New High School in Bungendore

State Significant
Development Application
(SSD-14394209)

Architectural + Landscape Design Report Addendum

Rev B
September 2022
Project No. 200096

14 Revised Waste Vehicle Turning Strategy

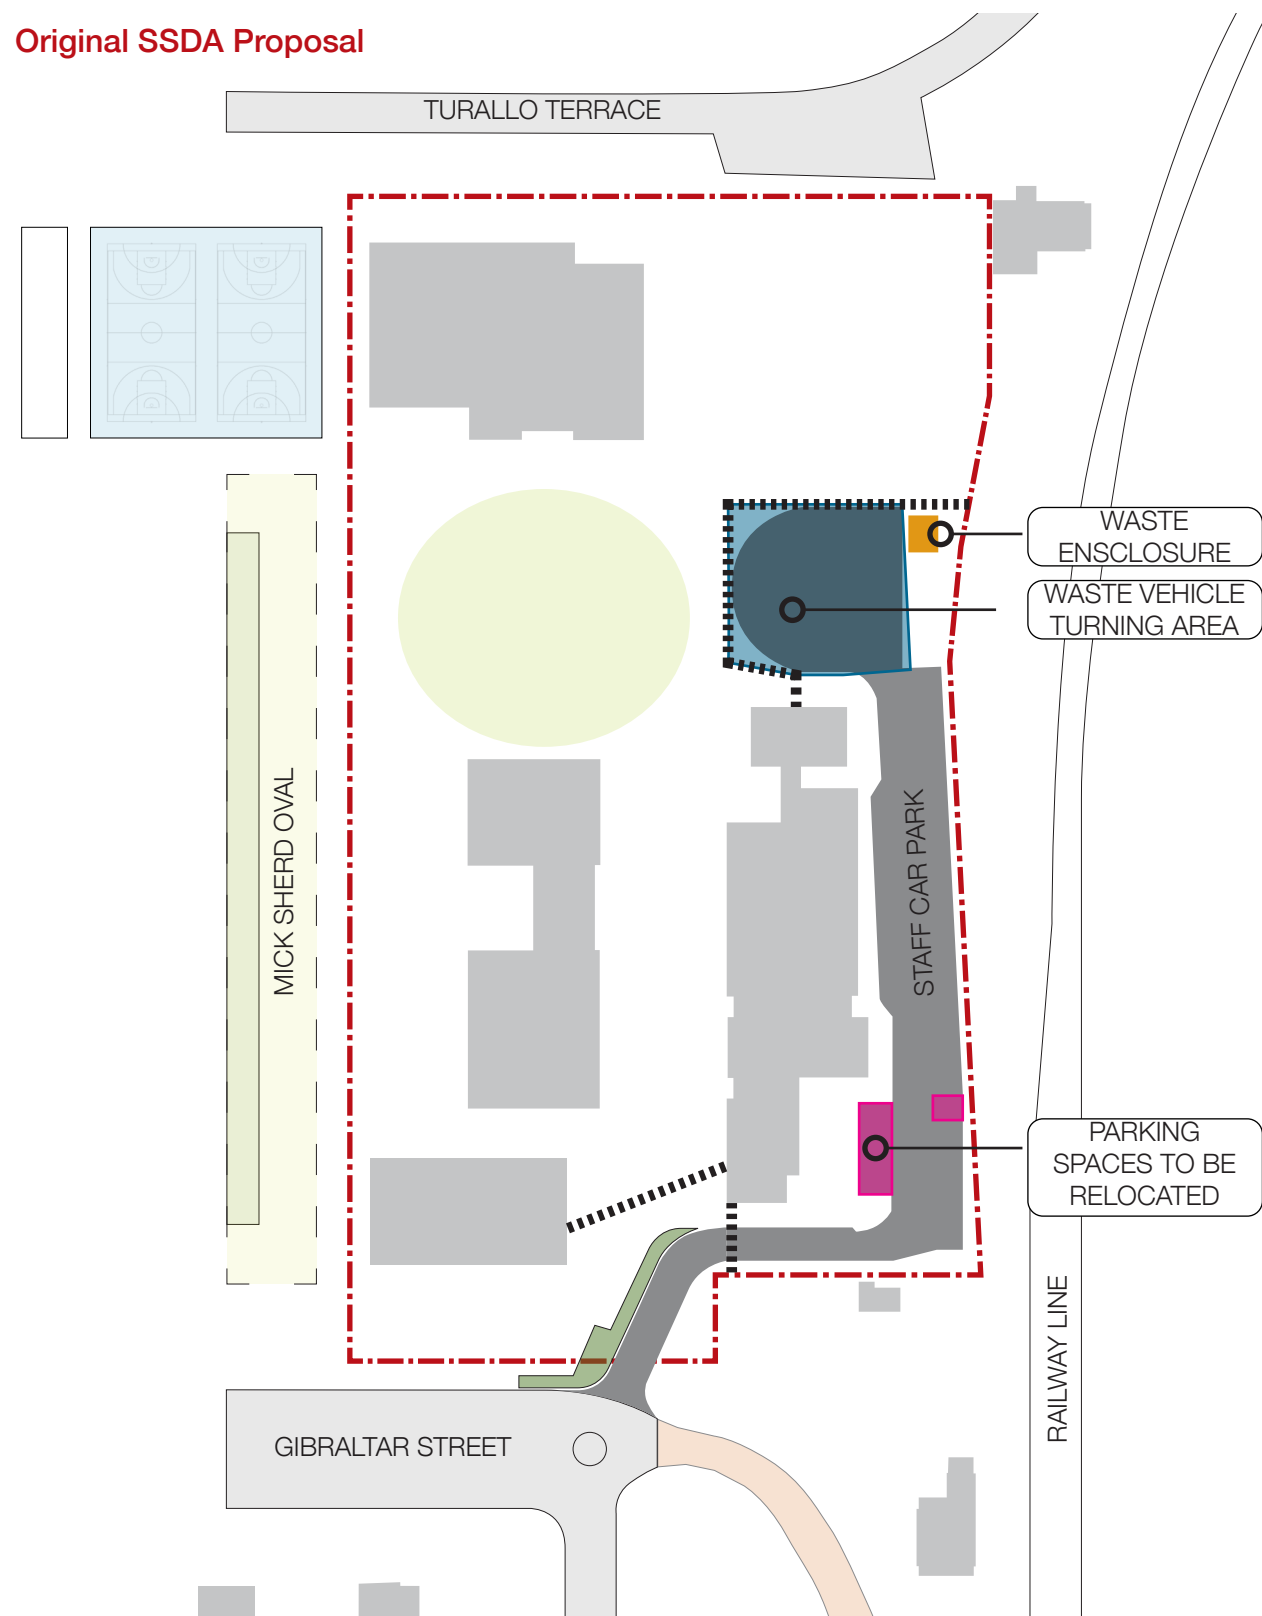
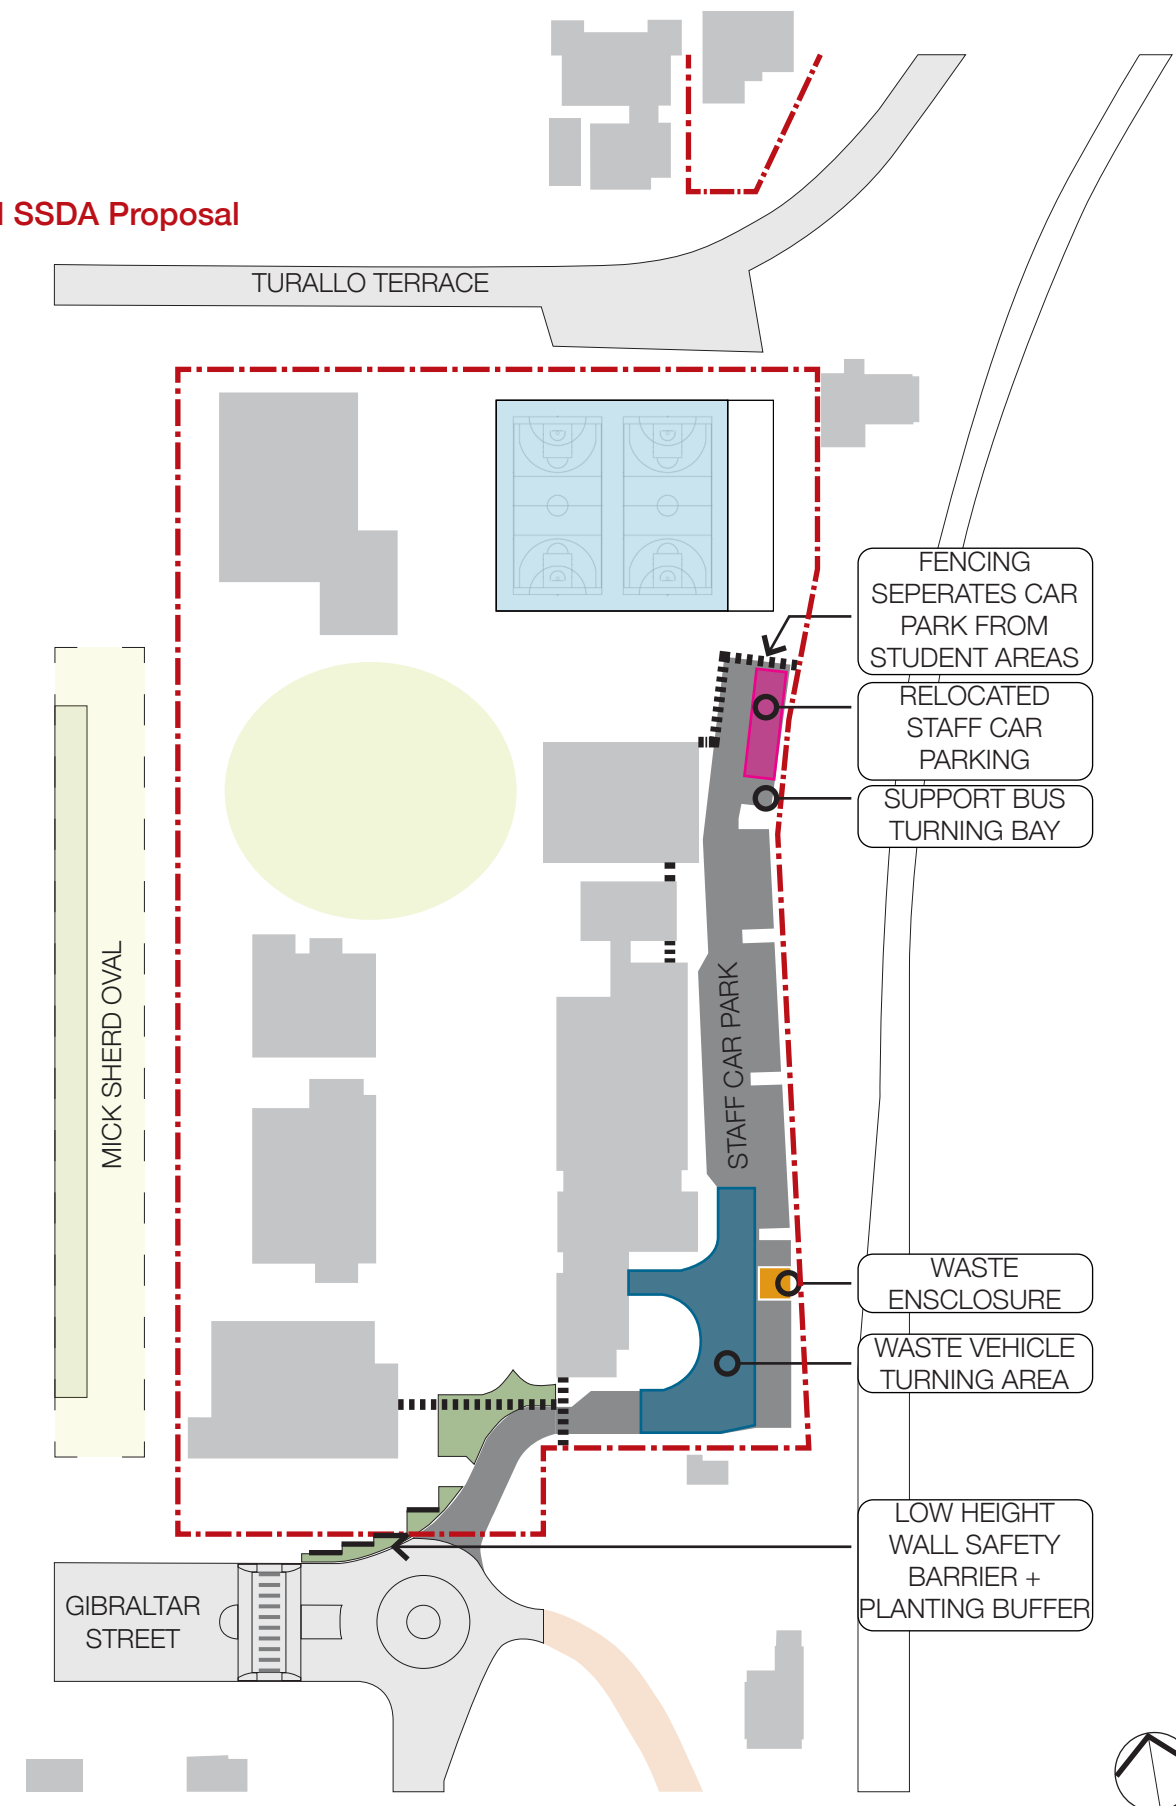
The waste vehicle turning circle has been removed from the proposal. The waste collection area has been relocated to the southern end of the existing carpark and a waste vehicle turning head has been added. A new turning bay is provided for assisted transport vehicles to the northern end of the car park. The existing car parking spaces impacted by the relocation of the waste turning area have been relocated to the north. The vehicle movement areas are to remain fenced, separating them from the main school grounds.

15 School Notice Board

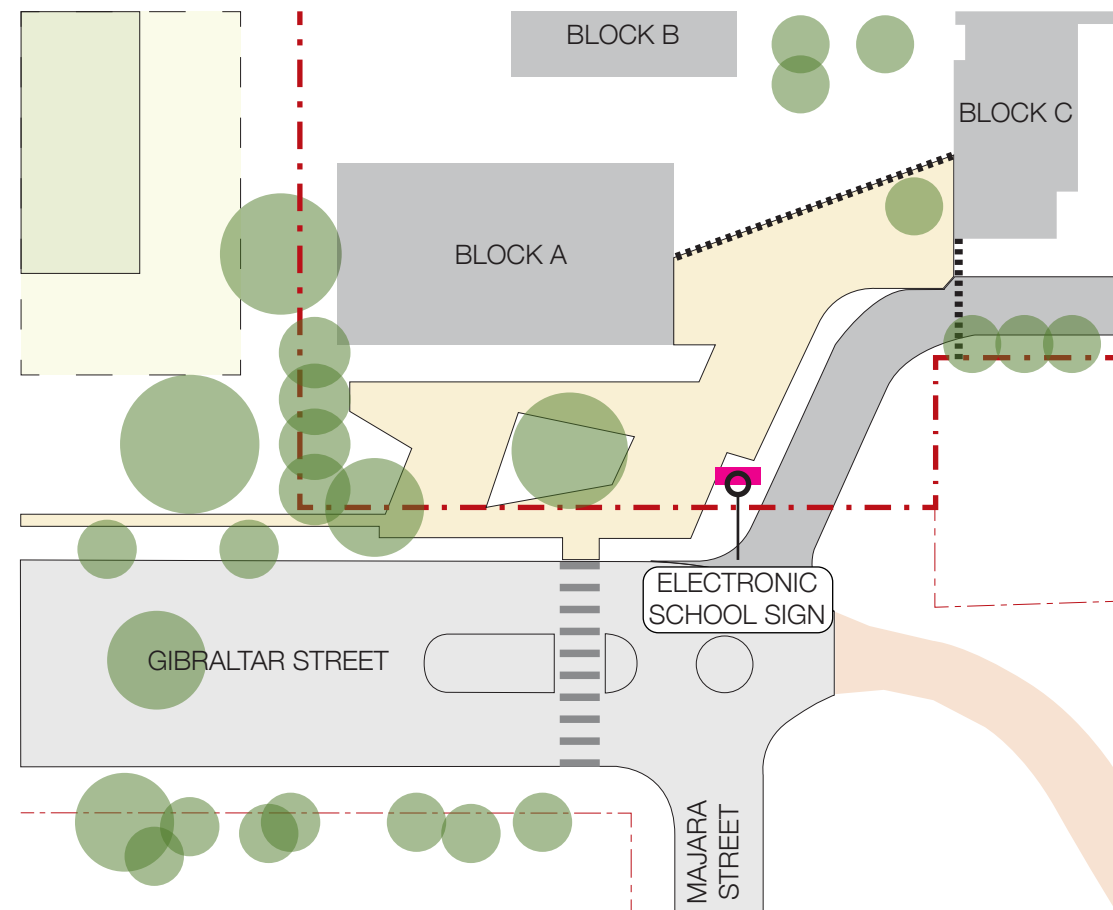
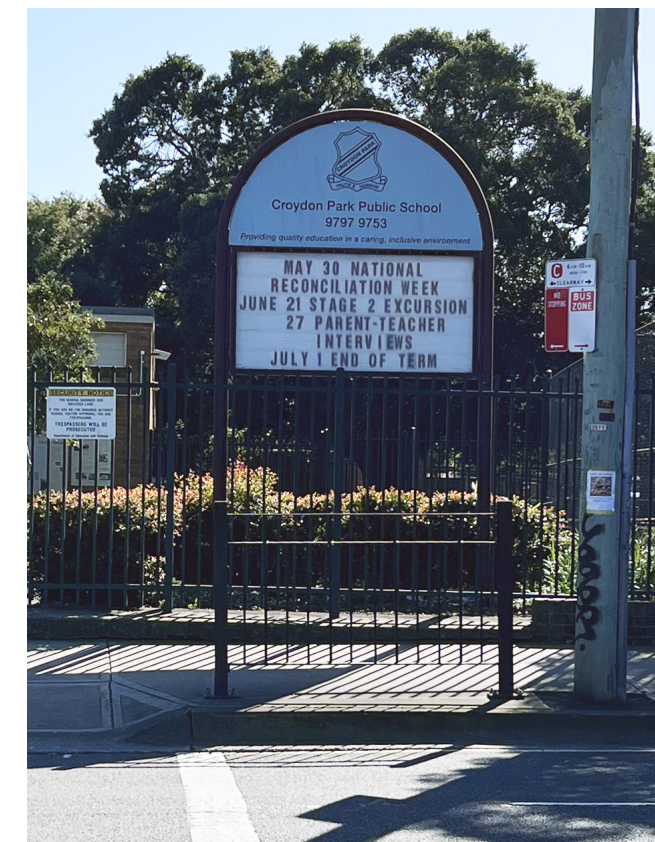
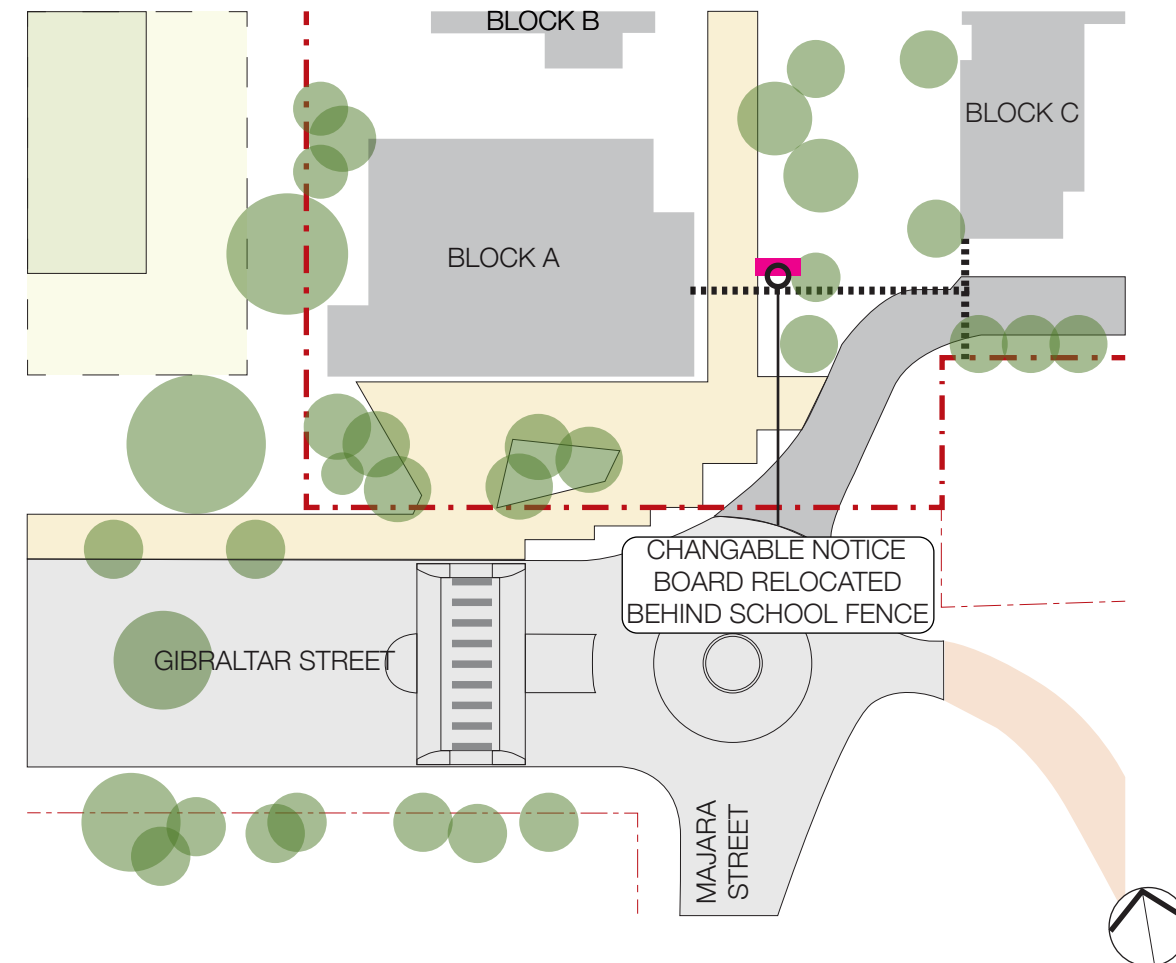
The electronic school sign has been replaced with a changable, static 'notice board' sign. The sign has been relocated further back from Majara Street, behind the school entrance to reduce its visual impact on the streetscape.

16 Relocated Scout Storage Shed

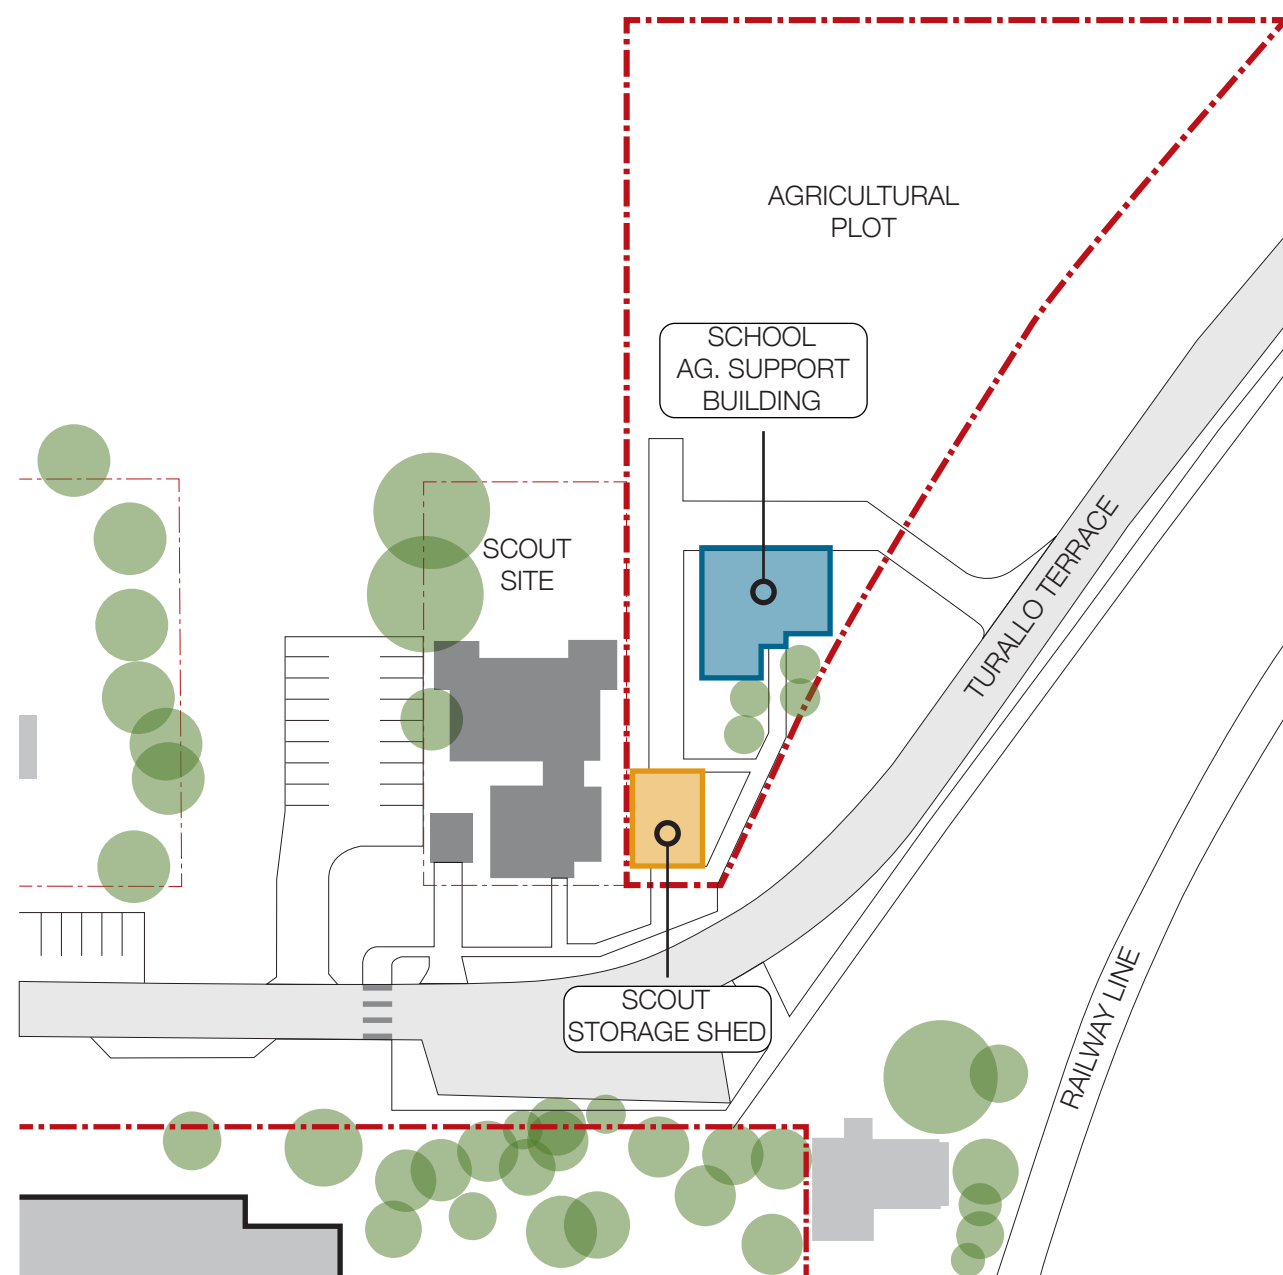
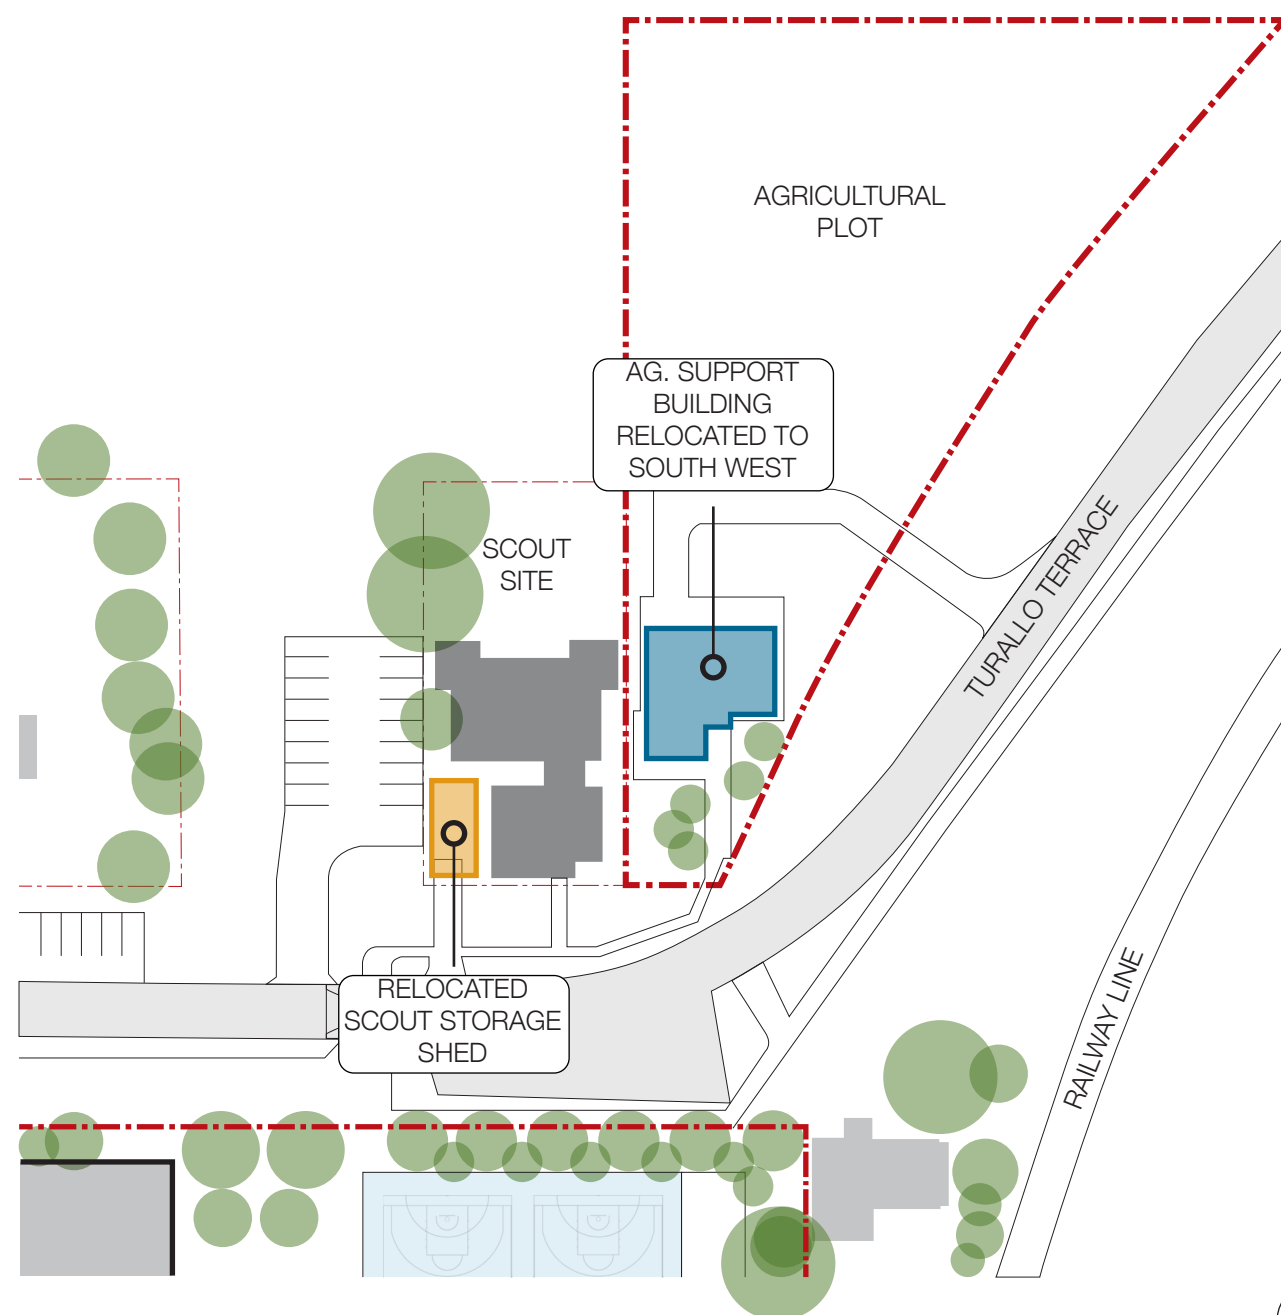
The Scout Storage Shed has been relocated from the Agricultural Plot to within the Scout site. The Scout Storage Shed will be subject to a separate planning pathway and does not form part of this application. The School Agricultural Support Building, Block F, has been repositioned and the landscape paths and driveways have been updated to suit the change.
